## **23-4D-3090 LMDR**

**23-4D-2080 T3NE.WL**  
**23-4D-2090 T3NE**  
**23-4D-2100 T3N.DS**  
**23-4D-2110 T3N.IS**

Side View

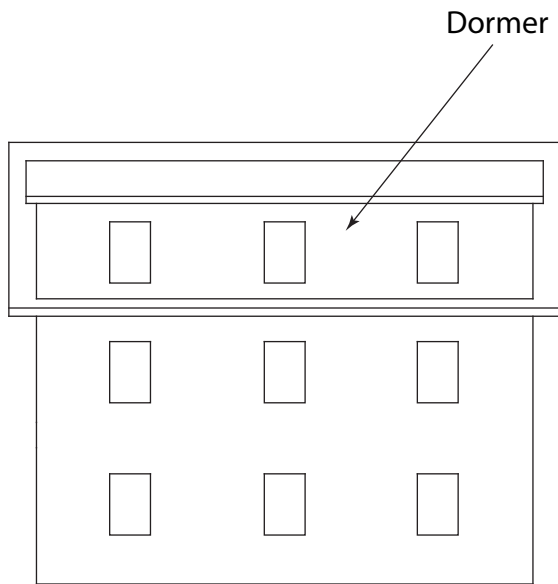
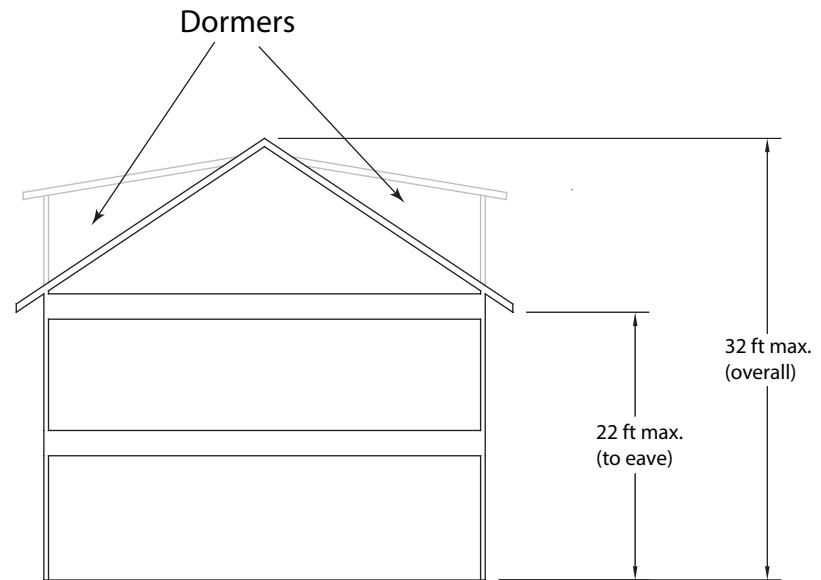
What is the definition of a “story”? Does an attic count as “story”? Since there are no apparent restrictions on length or slope of attic dormers in T3 and if an attic is not defined as a “story”, one could build a small perimeter gable “roof” around what would otherwise be essentially a third floor and call it an attic, circumventing the two-story requirement (see attached diagram).

ATTIC IS ESSENTIALLY A THIRD FLOOR  
WITH NO FAR LIMITATIONS AND NO TENT REQUIREMENTS IN T3, HOUSES COULD BE MASSIVE  
IF THERE ARE NO LIMITATIONS ON ATTIC DORMERS
